SUBJECT: Redline Pages to the Periodic Report 5 for the Upper Three Runs Integrator Operable Unit (IOU) (U) (SRNS-RP-2017-00548, Revision 1, July 2018) and Savannah River Site's Responses to Regulatory Comments on the Revision 0 Document, CERCLIS Number: 70

**Final SRS Responses to EPA Comments on
Periodic Report 5 for the Upper Three Runs IOU,
SRNS-RP-2017-00548, Revision 0, February 2018, CERCLIS Number: 70
Page 1 of 9**

Final SRS Responses to South Carolina
Department of Health and Environmental Control Comments on:
Periodic Report 5 for the Upper Three Runs Integrator Operable Unit (IOU) (U),
CERCLIS Number: 70 (SRNS-RP-2017-00548, Revision 0, February 2018)
Page 1 of 3

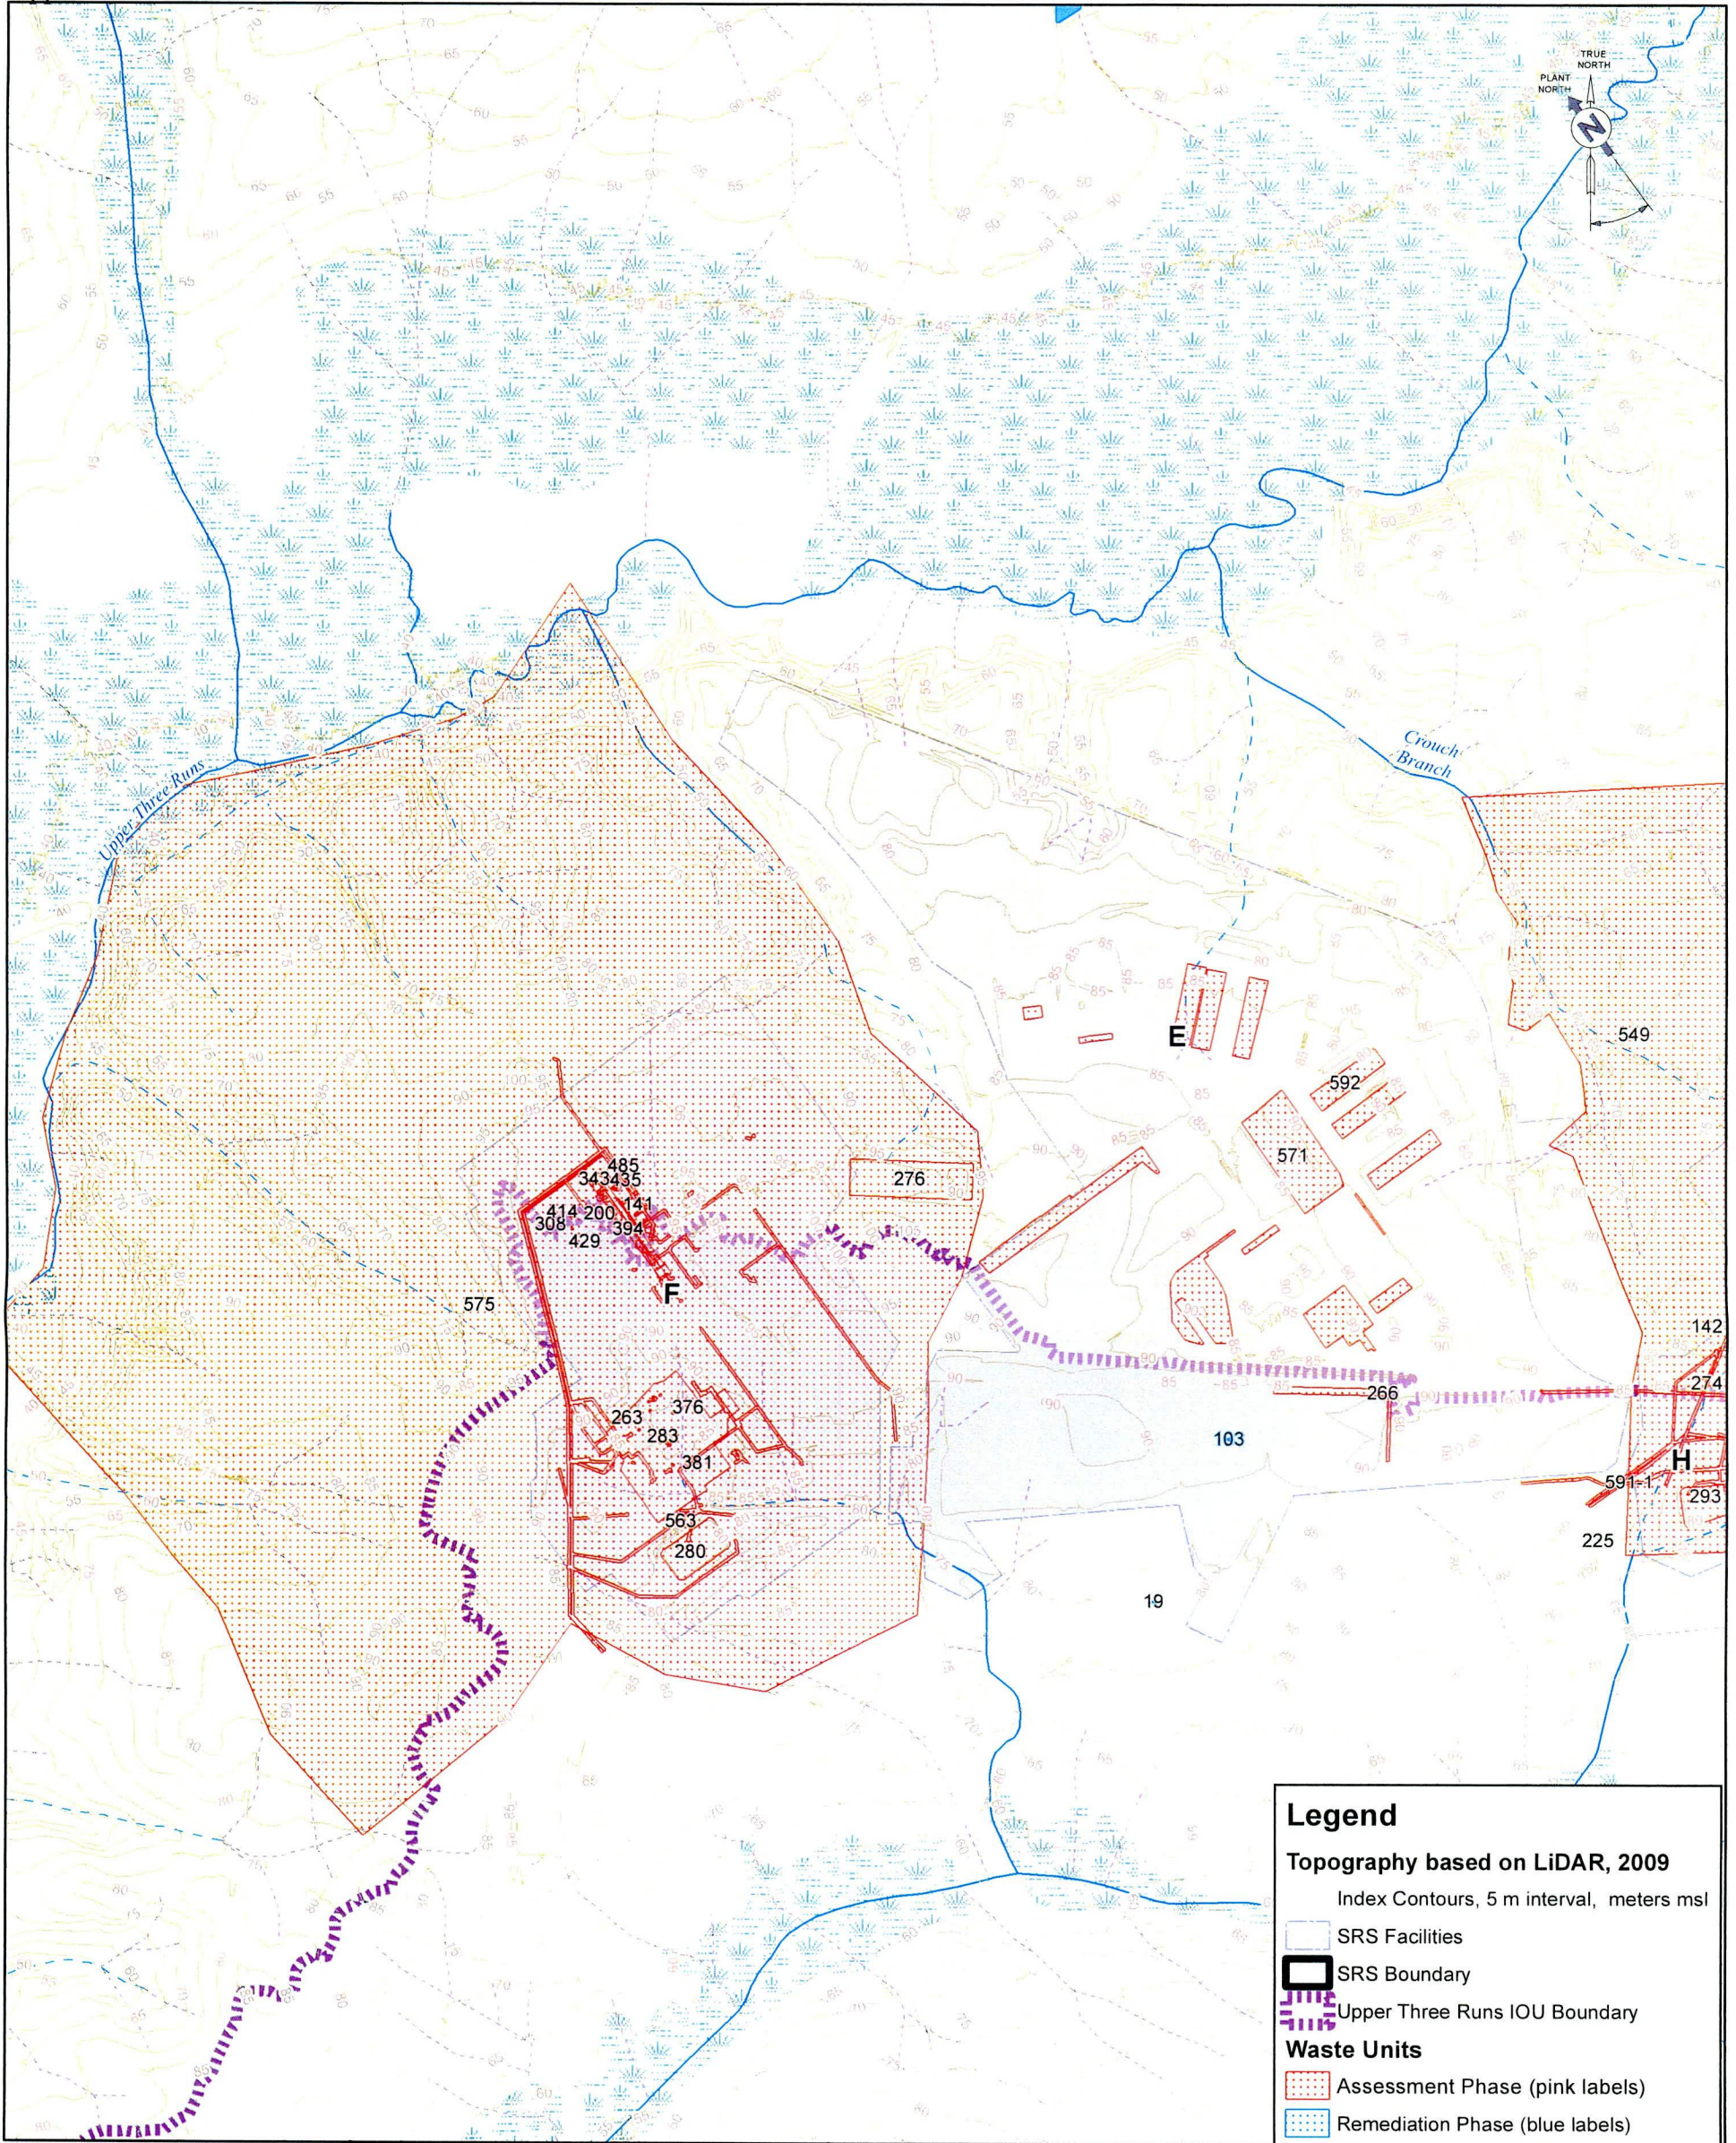
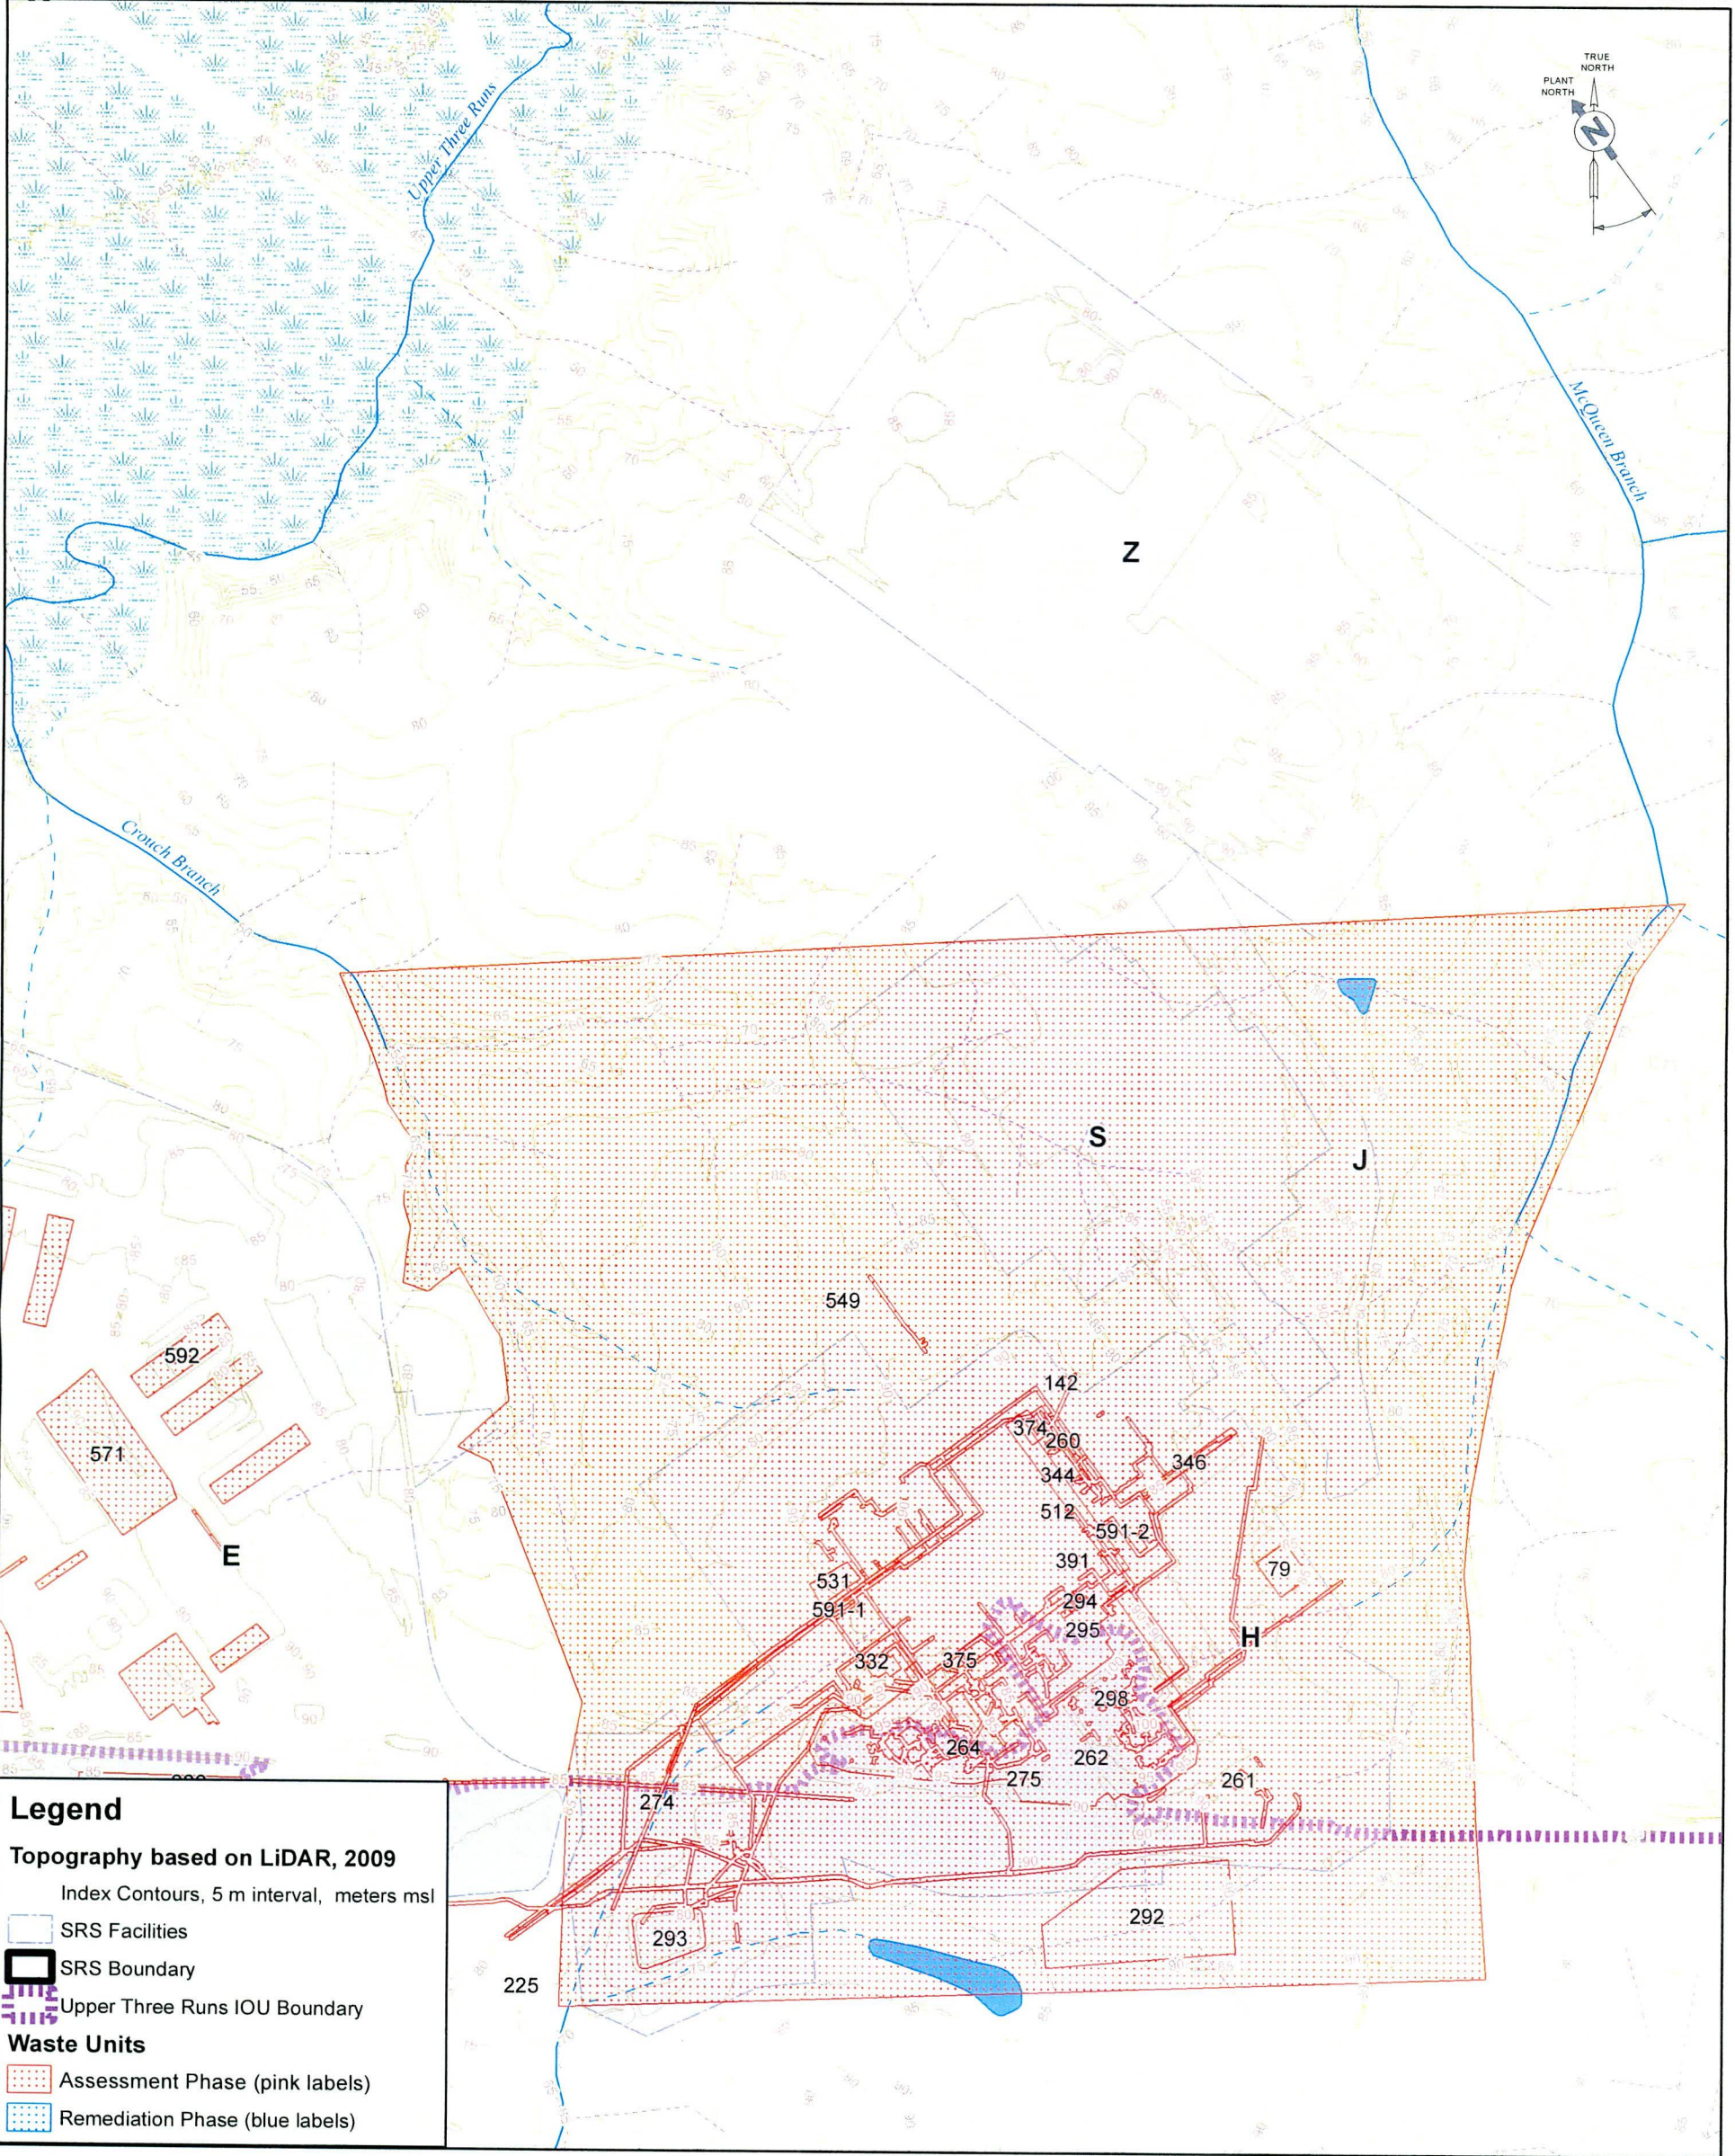
1. Figure 1-4a through Figure 1-4f, pages 1-23 through 1-33. Figures 1-4a through 1-4f should be labeled “Operable Units, Potentiometric Contours, and Groundwater Plumes Associated with the UTR IOU” for each unit area as stated on pages 1-23 through 1-33. Also, in the revision of PR5, please delete the additional copy of Figure 1-4c and insert Figure 1-4d.

Response: Agree. The new Figures 1-4a to 1-4d represent “Operable Units and Topography Associated with the UTR IOU”, and the new Figures 1-5a to 1-5d are “Operable Units, Potentiometric Contours and Groundwater Plumes Associated with the UTR IOU” and labeled appropriately.
